From: Moeller, Jason W - DNR
Sent: Thursday, December 23, 2010 9:38 AM
To: 'Hodgson, Scott A.'
Subject: RE: Dry Cleaners Etc-BRRTS #02-69-552218 Status

From: Hodgson, Scott A. [mailto:sahodgson@terracon.com]
Sent: Tuesday, December 21, 2010 02:51 PM
To: Moeller, Jason W - DNR
Cc: Paul/Robin Zuege; Schroyer, Blaine R.
Subject: Dry Cleaners Etc-BRRTS #02-69-552218 Status

TEMPORARY WELL GROUNDWATER DATA MAP (9/2/2010)
 DRYCLEANERS, ETC.
 102 EAST COOK STREET
 NEW LONDON WISCONSIN

FIG. No.
 3

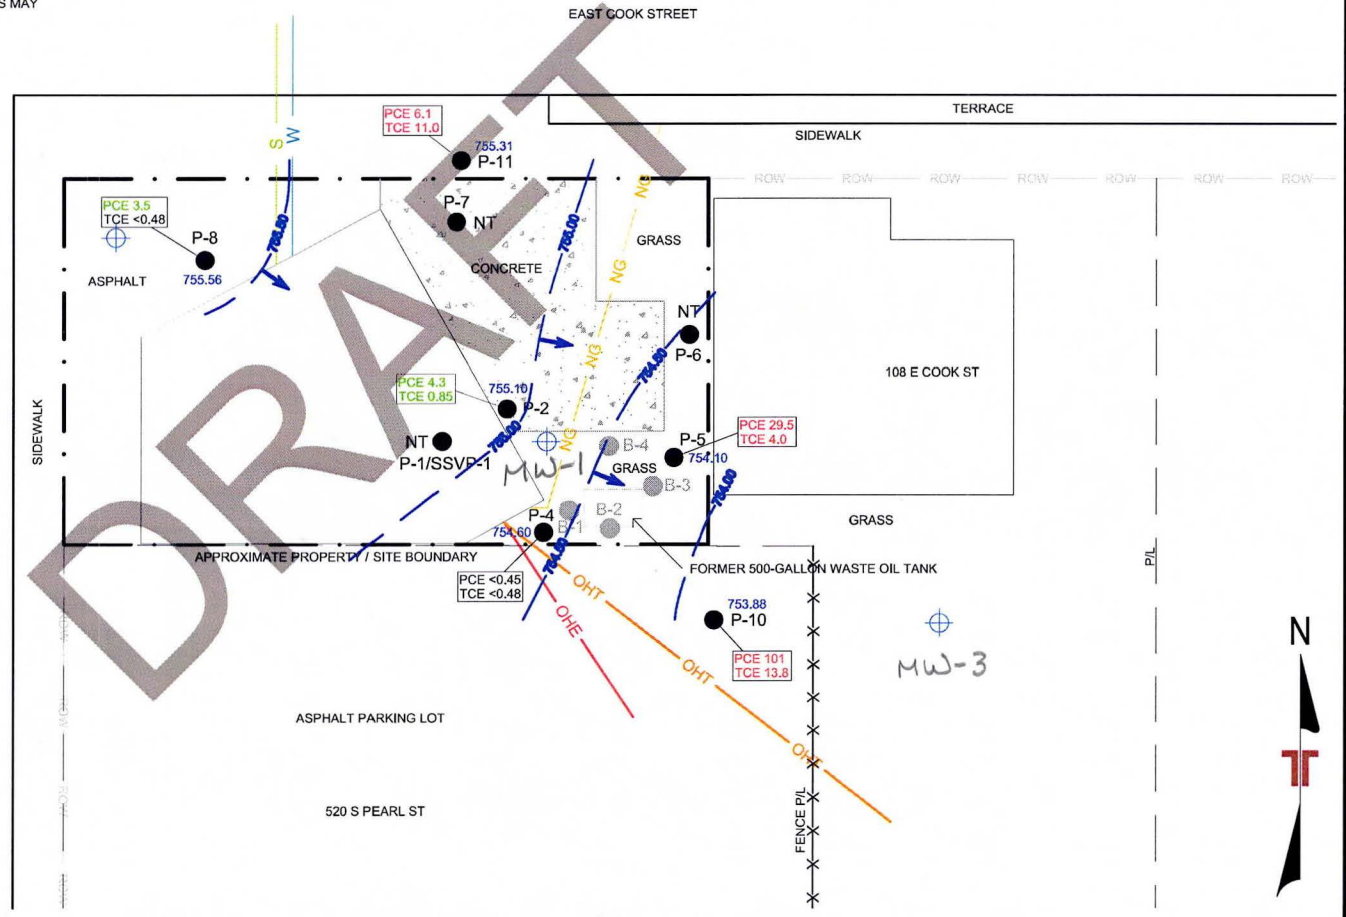
Based on the data to date, proposed monitoring well locations are provided on the groundwater map for your review and approval. In accordance with our original proposal/work plan, we are proposing construction of four water table observation wells. Depth to groundwater is approximately 28 feet below

I agree, we need to proceed with Stage II. Therefore, you have DNR approval to proceed with Stage II as proposed.
